Access Compliance Report

Public Rights-of-Way

Intersection ID: 45504	Main Street: FIRST_BLOOM_RD	Cross Street: MEADOW_BOTTOM_RD	Location: N
ADA ID: AE3EC15F1893	Ramp Type: PerpDiag	Initial Pass/Fail: Fail	Overall Compliance: No
			Severity Score: 33.75

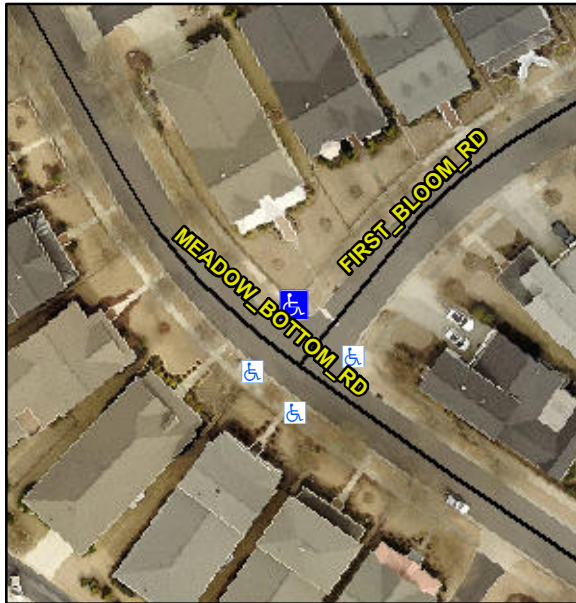
Not Found, R304.5.1, R304.2.2, R304.5.3

Compliance	Description	Data	Compliance	Description	Data
N/A	Ramp Length (in)	71.0	No	Ramp Slope (%)	9.9
No	Ramp Width (in)	36.0	No	Ramp XSlope (%)	5.3
N/A	Flare Type LT	N/A	N/A	Flare Type RT	N/A
N/A	Flare Slope LT (%)	N/A	N/A	Flare Slope RT (%)	N/A
N/A	Flare Traversable LT?	N/A	N/A	Flare Traversable RT?	N/A
N/A	Landing Length (in)	N/A	N/A	DWS Provided?	N/A
N/A	Landing Width (in)	N/A	N/A	DWS Contrast?	N/A
N/A	Landing Slope (%)	N/A	N/A	DWS Length (in)	N/A
N/A	Landing X Slope (%)	N/A	N/A	DWS Full Width?	N/A
N/A	Landing Curb? (Y/N)	N/A	N/A	DWS Offset (in)	N/A
N/A	Shared Landing?	N/A			
N/A	Gutter Ponding?	N/A	N/A	Gutter Slope (%)	N/A
N/A	Gutter Lip Ht (in)	N/A	N/A	Gutter X Slope (%)	N/A
N/A	Painted X Walk1?	No	N/A	Painted X Walk2?	No
	X Walk 1 Direction	To SW		X Walk 2 Direction	To SE
N/A	X Walk 1 Width (in)	N/A	N/A	X Walk 2 Width (in)	N/A
	X Walk 1 Slope (%)	3.4		X Walk 2 Slope (%)	0.5
	X Walk 1 X Slope (%)	1.9		X Walk 2 X Slope (%)	3.7

Remove & Replace Curb Ramp With Two New Directional Ramps or Equivalent.
